INDESIT company

Model type:
BAAN10

Commercial code:
F033938

N1030093fig1

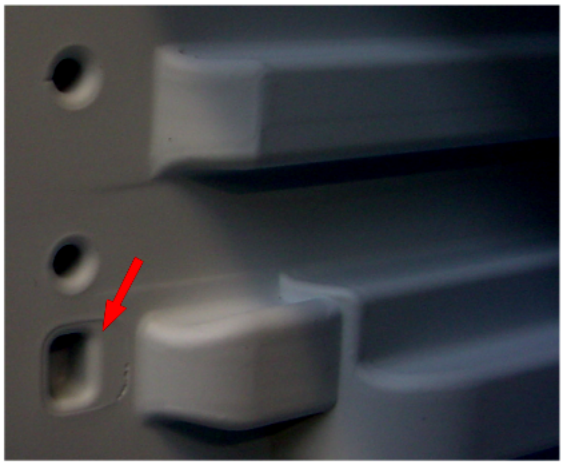
n1030093: New fixing of evaporator on static fridge-freezers (05 range) 60 cm,Melano

From August 05 (serial no. 50802.0001) the freezer evaporator is secured to the cabinet by a plastic profile.
The cabinet walls have been modified to create locations to house the profile, which is installed on the front of each evaporator plate (see photo N1030093fig1- fig2 - fig3)
The profile cannot be fitted on premodification appliances, so technical personnel must continue to fit the rh and lh supports on these models (see photo N1030093fig4)

New parts
C00141135 = WHITE PROFILE L=443.5 MM

Parts replaced
C00075596 = EVAPORATOR RH SUPPORT
C00075597 = EVAPORATOR LH SUPPORT

N1030093fig1

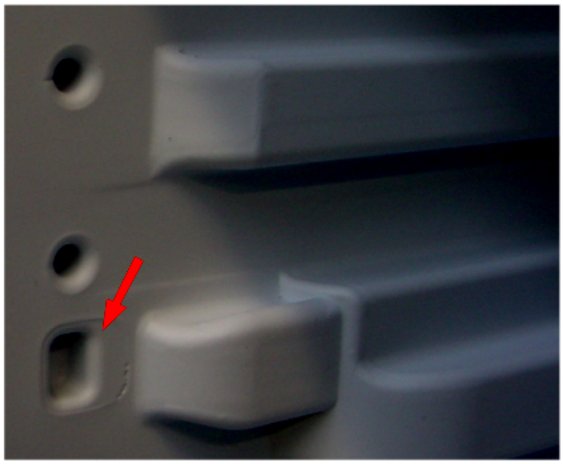
n1030094: New fixing of evaporator on static fridge-freezers (05 range) 60 cm, Lodowek

From August 05 (serial no. 50820.0001) the freezer evaporator is secured to the cabinet by a plastic profile.
The cabinet walls have been modified to create locations to house the profile, which is installed on the front of each evaporator

plate (see photo N1030093fig1- fig2 - fig3)
The profile cannot be fitted on premodification appliances, so technical personnel must continue to fit the rh and lh supports on these models (see photo N1030093fig4)

New parts
C00141135 = WHITE PROFILE L=443.5 MM

Parts replaced
C00075596 = EVAPORATOR RH SUPPORT
C00075597 = EVAPORATOR LH SUPPORT
